Product / Process Change Notification (PCN)

PCN #: PCN_WL-SWTP_20210701_1

Affected Series: WL-SWTP; 1583012xx

PCN Date: April 01, 2021

TECHNICAL DRAWING:

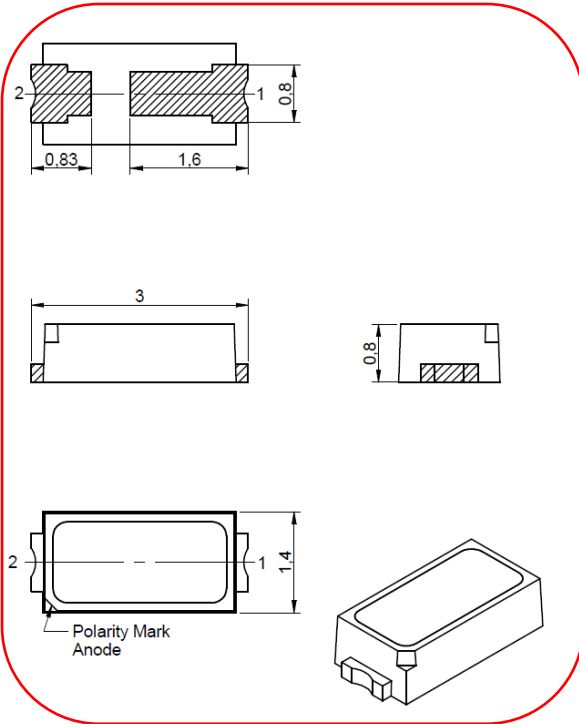
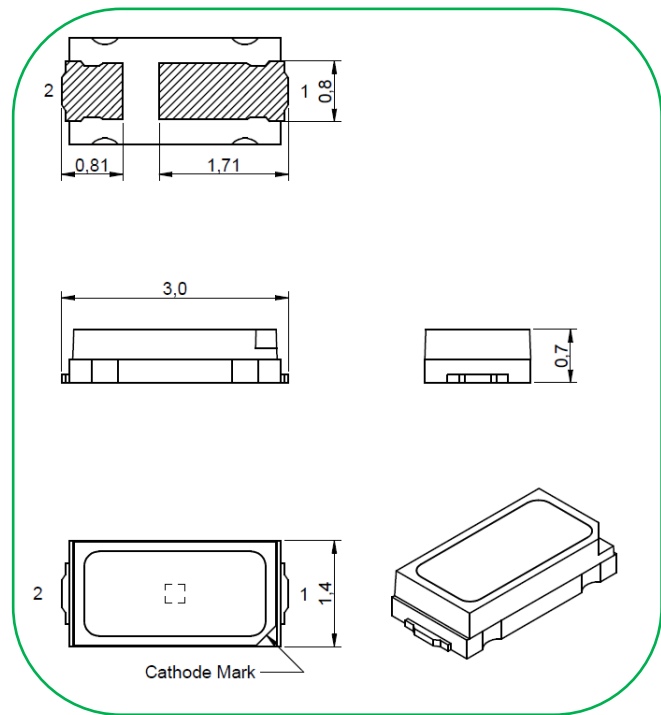
The lead frame will be changed which changes details of the components form and component marking.

See technical drawing below for changes.

SOLDERING PAD:

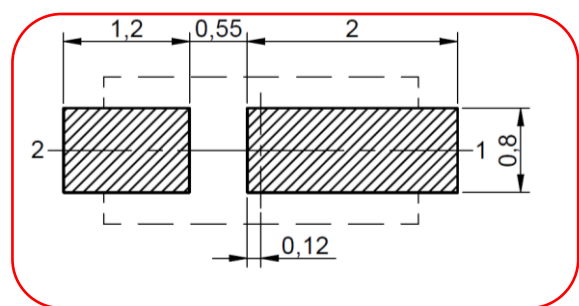
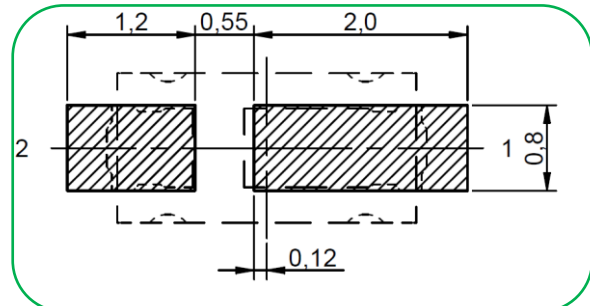
No change in soldering pad, but drawings are updated.

PACKAGING DRAWING:

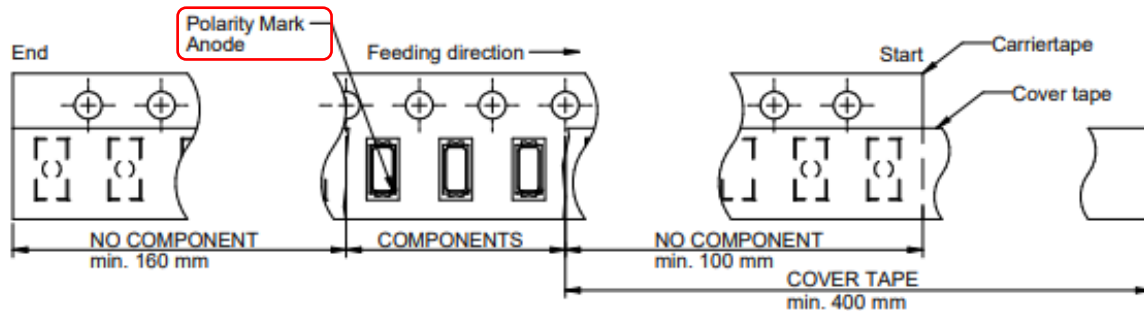
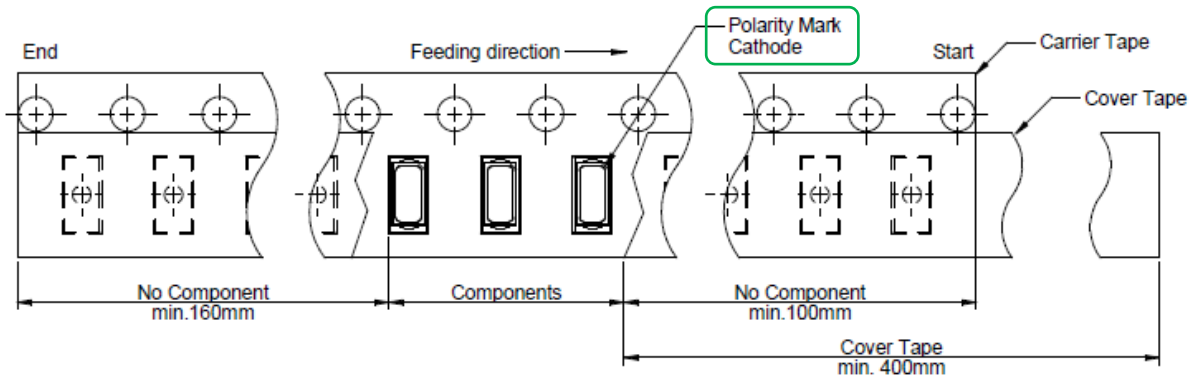
No change in packaging, but drawings are updated.
